SERVICE BULLETIN

FEBRUARY 1995

PRODUCT RECALL: TIPS™ FUEL CAP

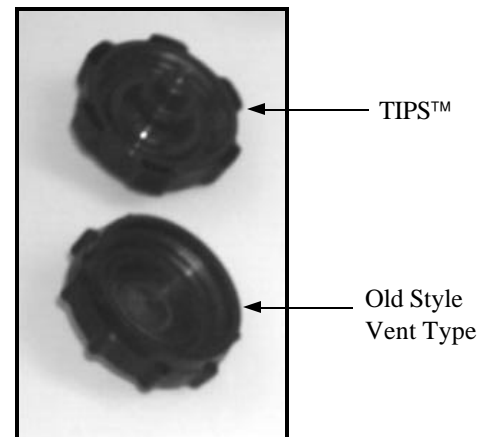
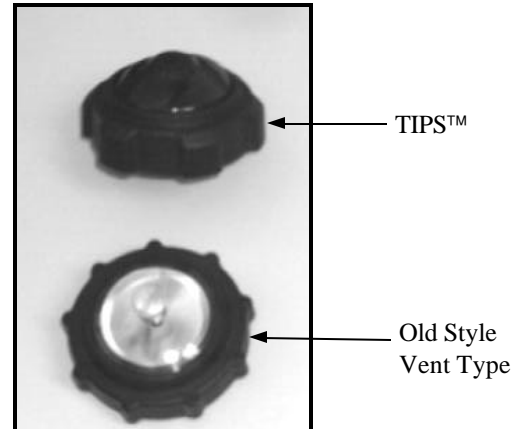
The fuel cap develops a leak during operation. Fuel spurts straight up (1 to 2 inches) from center vent hole. The spillage gets worse when temperature increases.

The new style TIPS™ cap is design to prevent spillage if kart is turned upside down. It does this job very well, but when operated under normal conditions, fuel is forced into cap from movement of kart around track. When fuel gets inside cap, fuel stays in and the only place for it to go is out

Replace TIPS™ cap with old version type fuel cap. Return defective caps when you receive new ones.

TIPS™: **Part#01080**

Old Style Kelch Cap: **Part#01081**
